Duke Power Company
ATTN: Mr. Austin C. Thies
Senior Vice President
422 South Church Street
Post Office Box 2178
Charlotte, North Carolina 28201

The Commission has issued the enclosed Amendment No. 6, Technical Specification Change No. 16 for License No. DPR-38; Amendment No. 6, Technical Specification Change No. 11 for License No. DPR-47; and Amendment No. 3, Technical Specification Change No. 3 for License No. DPR-55, for the Oconee Nuclear Station, Units 1, 2, and 3. These amendments are in response to your request dated September 20, 1974, and subsequent letters dated October 8, 1974, and October 31, 1974.

These amendments include the Technical Specification changes required for the second fuel cycle operation of Oconee Unit 1. The proposed Control Rod Withdrawal Limit For 4 Pump Operations (Figure 3.5.2-1A2) after 250 ± 5 full power days of operation has not been included in this change since it does not conform to the Interim Acceptance Criteria for ECCS and your proposed Final Acceptance Criteria (Appendix K) Technical Specifications have not yet been approved.

AMENDMENT NO. 6 TO FACILITY LICENSE NO. DPR-38,
CHANGE NO. 16 TO TECHNICAL SPECIFICATIONS;

Figure 2.1-1A | 16/11/3

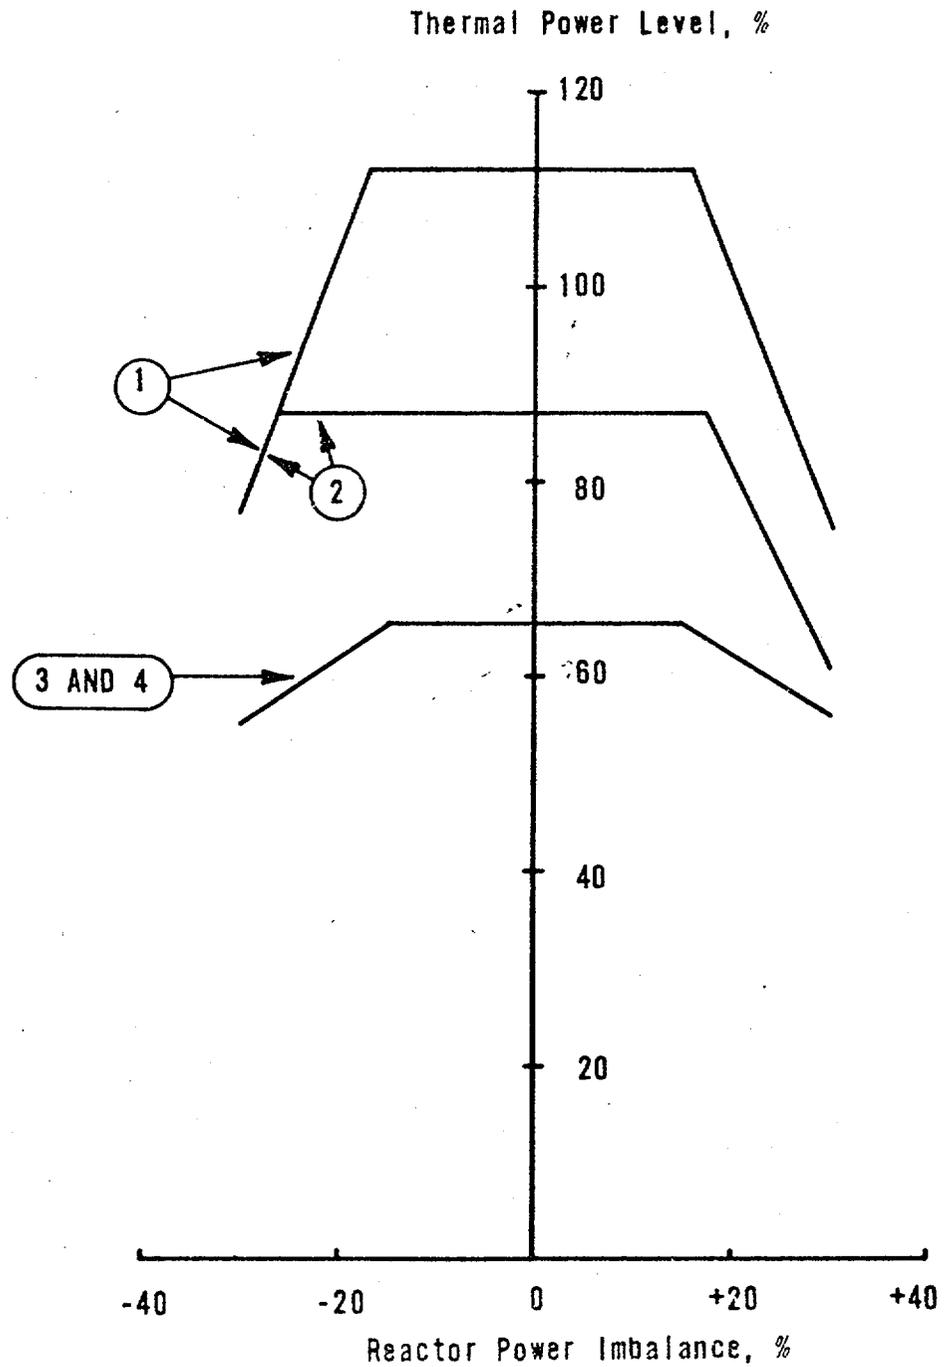
The curve presented in Figure 2.1-1A represents the conditions at which a minimum DNBR of 1.32 is predicted for the maximum possible thermal power (112 percent) when four reactor coolant pumps are operating (minimum reactor coolant flow is 107.6 percent of 131.3×10^6 lbs/hr.). This curve is based on the combination of nuclear power peaking factors, with potential fuel densification effects, which result in a more conservative DNBR than any other shape that exists during normal operation.

The curve of Figure 2.1-1A is the most restrictive of all possible reactor coolant pump-maximum thermal power combinations shown in Figure 2.1-3A (because the four-pump pressure - temperature restriction is known to be more limiting than the 3 and 2 pump combinations, only the four pump limit has been shown on Figure 2.1-3A).

The combination of the reactor system pressure and coolant temperature shall not exceed the safety limit as defined by the locus of points established in Figure 2.1-1A-Unit 1. If the actual pressure/temperature point is below

Figure 2.1-2A 16/11/3

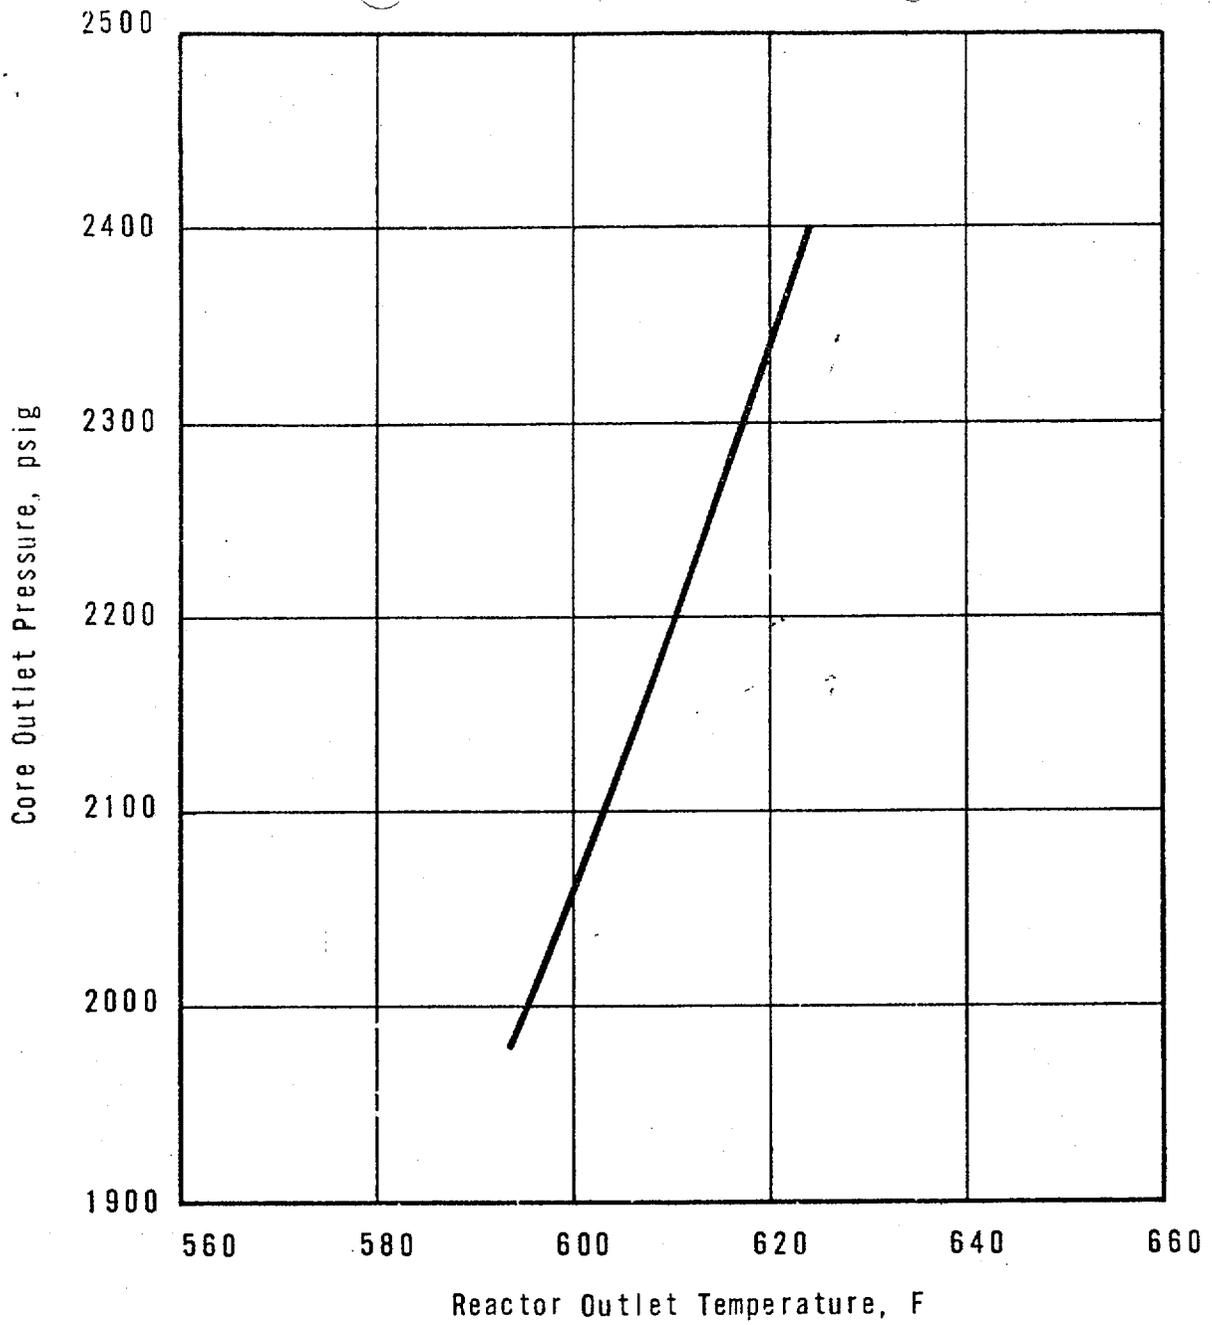
The curves of Figure 2.1-2A are based on the more restrictive of two thermal limits and include the effects of potential fuel densification:

The specified flow rates for Curves 1, 2, 3 and 4 of Figure 2.1-2A correspond to the expected minimum flow rates with four pumps, three pumps, one pump in each loop and two pumps in one loop, respectively.

The combination of reactor thermal power and reactor power imbalance (power in the top half of the core minus the power in the bottom half of the core expressed as a percentage of the rated power) shall not exceed the safety limit as defined by the locus of points (solid line) for the specified flow set forth in Figure 2.1-2A-Unit 1. If the actual reactor-thermal-power/power

Figure 2.1-3A | 16/11/3

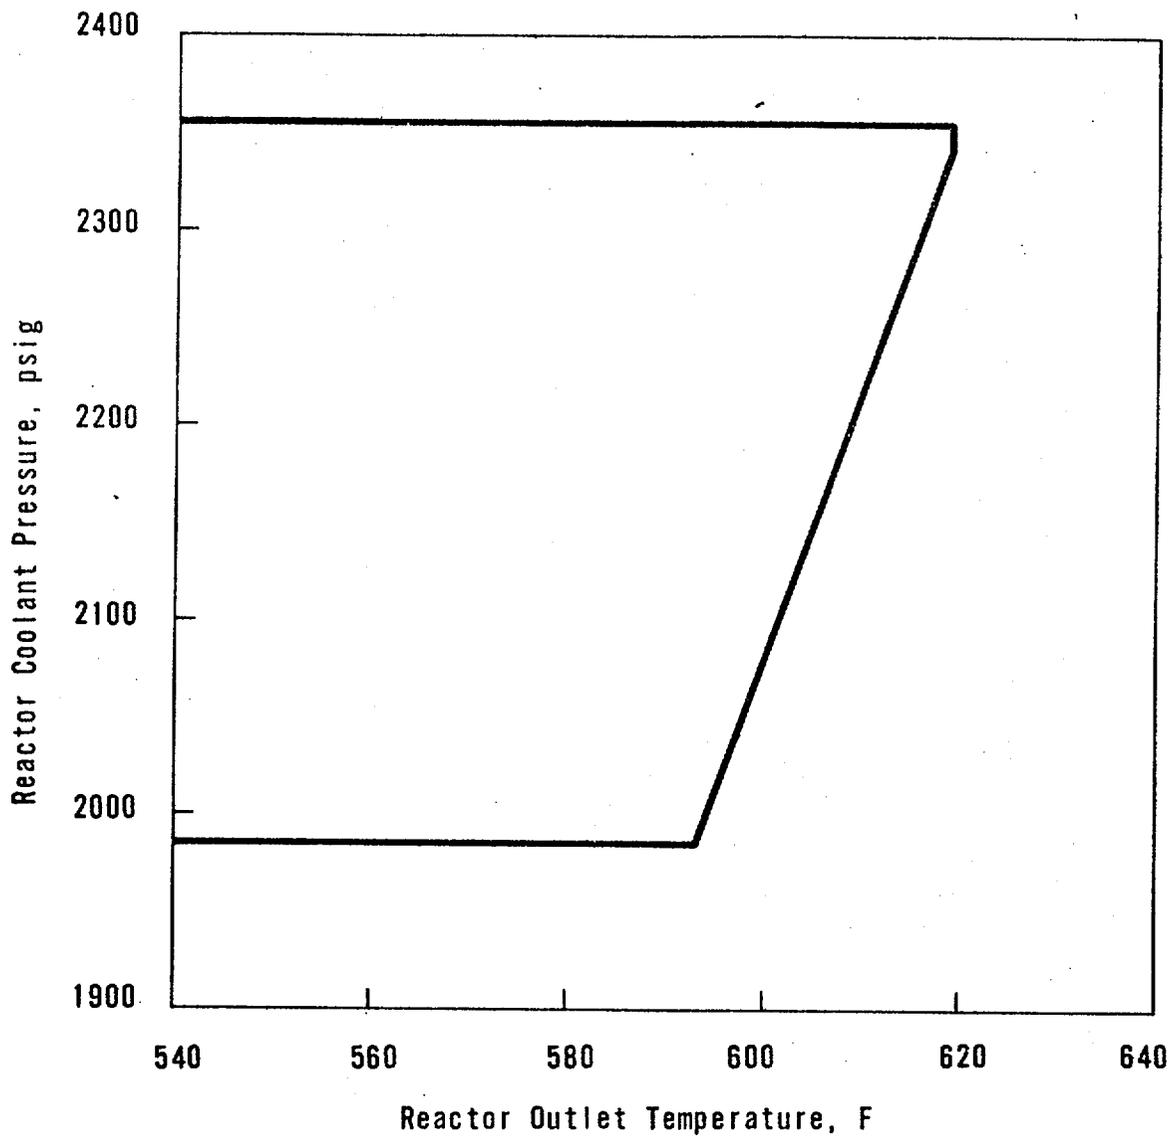
For Figure 2.1-3A, a pressure-temperature point above and to the left of the curve would result in a DNBR greater than 1.32. The 1.32 DNBR curve for four-pump operation is more restrictive than any other reactor coolant pump situation because any pressure/temperature point above and to the left of the four pump curve will be above and to the left of the other curves.

Figure 2.3-1A | 16/11/3

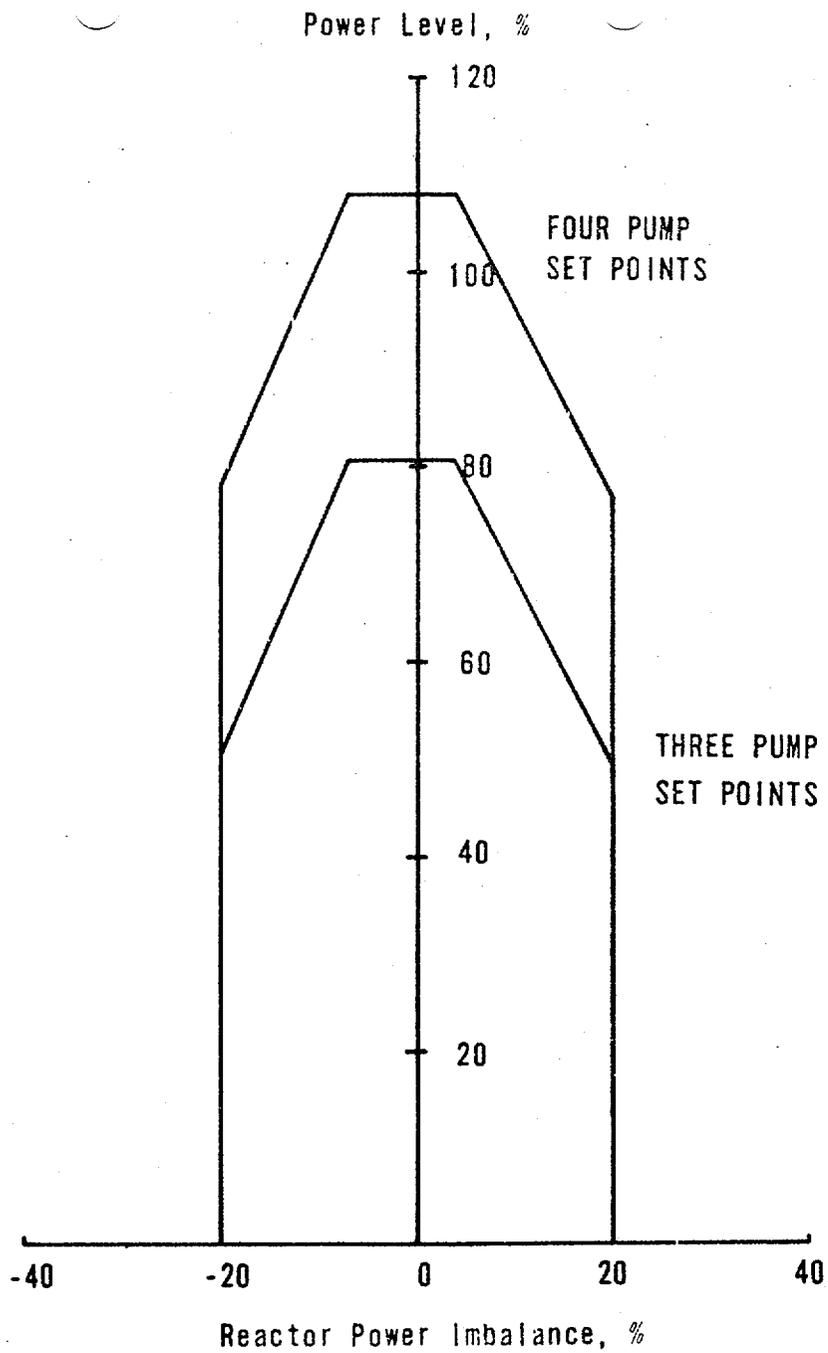
During a startup accident from low power or a slow rod withdrawal from high power, the system high pressure set point is reached before the nuclear overpower trip set point. The trip setting limit shown in Figure 2.3-1A - Unit 1
 2.3-1B - Unit 2
 2.3-1C - Unit 3

The low pressure (1985) psig and variable low pressure (13.77 T_{out}-6181) trip 16/11/3
 (1800) psig (16.25 T_{out}-7756)
 (1800) psig (16.25 T_{out}-7756)
 setpoints shown in Figure 2.3-1A have been established to maintain the DNB
 2.3-1B
 2.3-1C

The high reactor coolant outlet temperature trip setting limit (619 F) shown in Figure 2.3-1A has been established to prevent excessive core coolant
 2.3-1B
 2.3-1C

Figure 2.3-2A1 / 16/11/

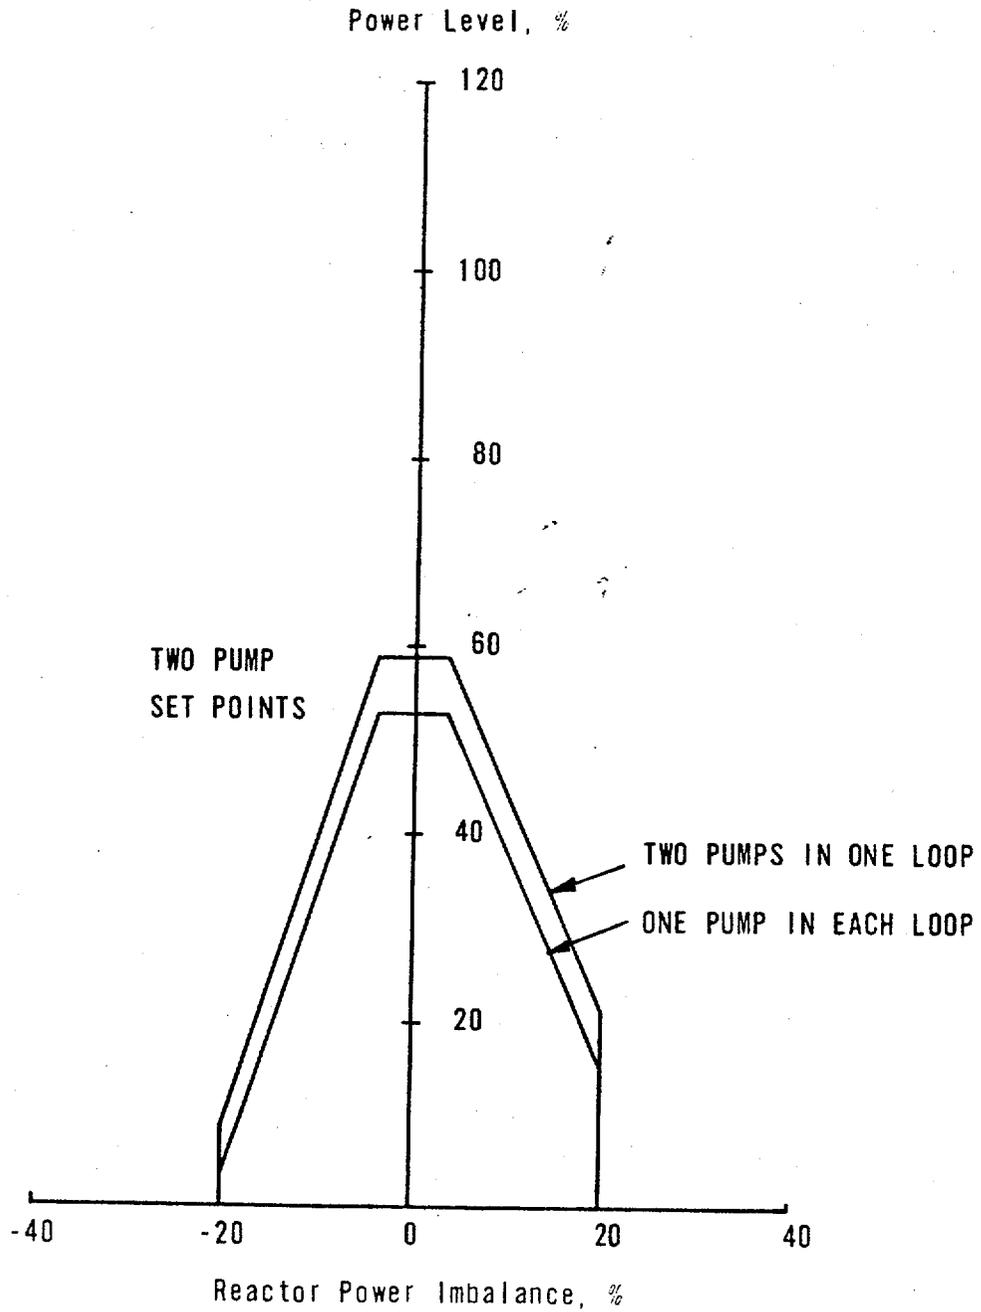
The power-imbalance boundaries are established in order to prevent reactor thermal limits from being exceeded. These thermal limits are either power peaking kw/ft limits or DNBR limits. The reactor power imbalance (power in the top half of core minus power in the bottom half of core) reduces the power level trip produced by the power-to-flow ratio such that the boundaries of Figure 2.3-2A1 } Unit 1 are produced. The power-to-flow ratio reduces the power

Figure 2.3-2A2 | 16/11/3

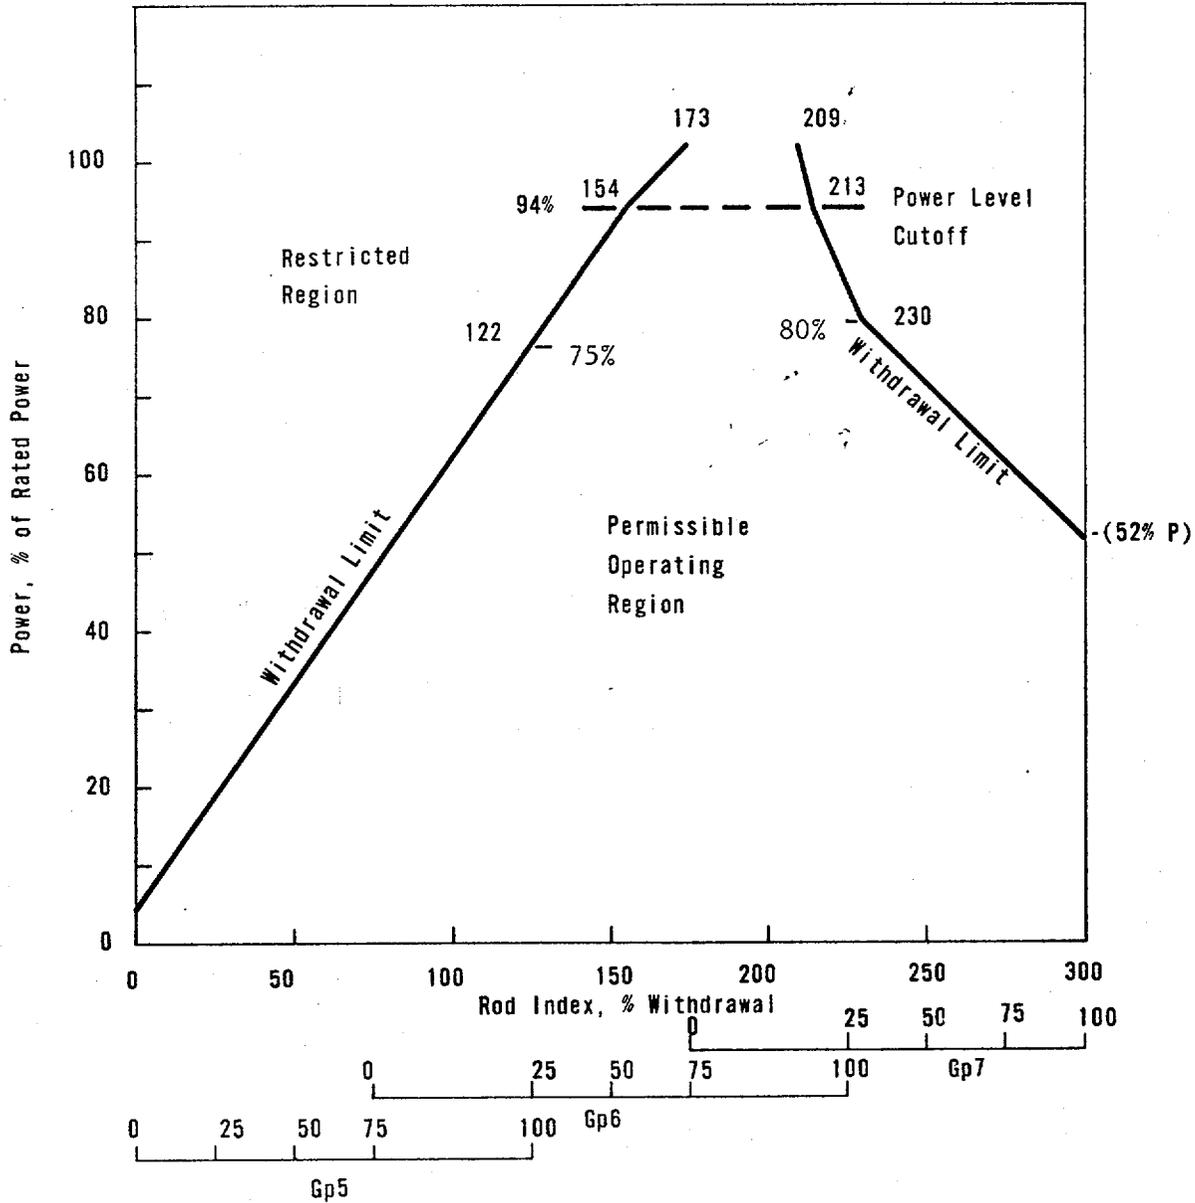
1. Reset the pump contact monitor power level trip setpoint to 55.0%.
2. (Unit 1) Reset the protective system maximum allowable setpoint as shown in Figure 2.3-2A2.

Figure 3.5.2-1A1 | 16/11/3

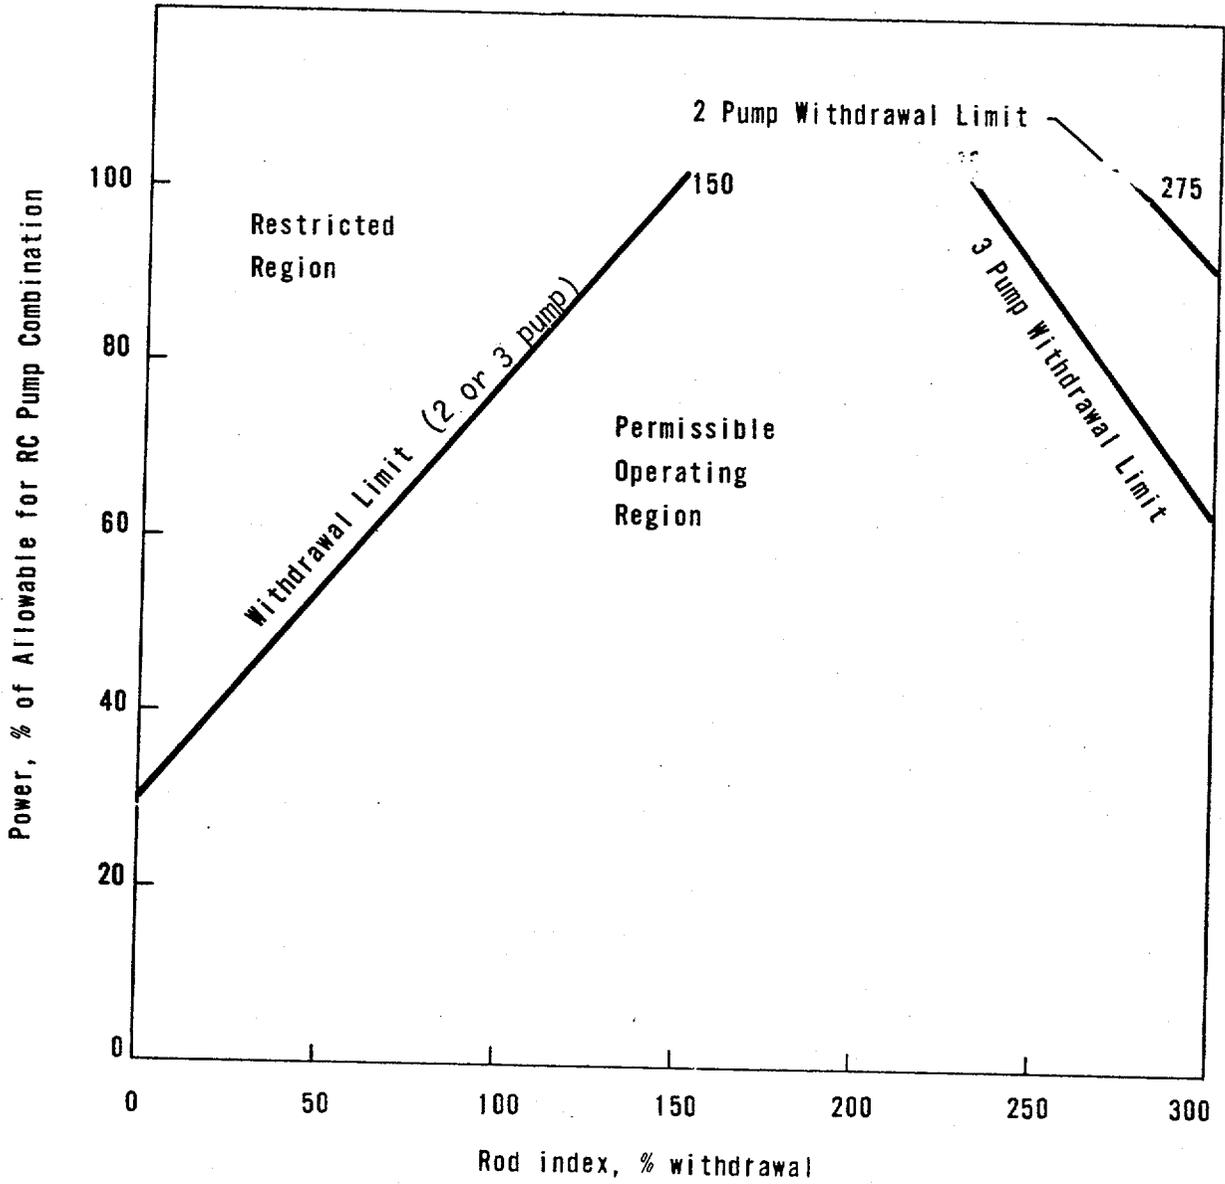
- d. Except for physics tests, power shall not be increased above the power level cutoff as shown on Figure 3.5.2-1A1 (Unit 1), 3.5.2-1B1, 3.5.2-1B2, and 3.5.2-1B3 (Unit 2), and 3.5.2-1C1, 3.5.2-1C2, and 3.5.2-1C3 (Unit 3), unless the following requirements are met. | 16/11/
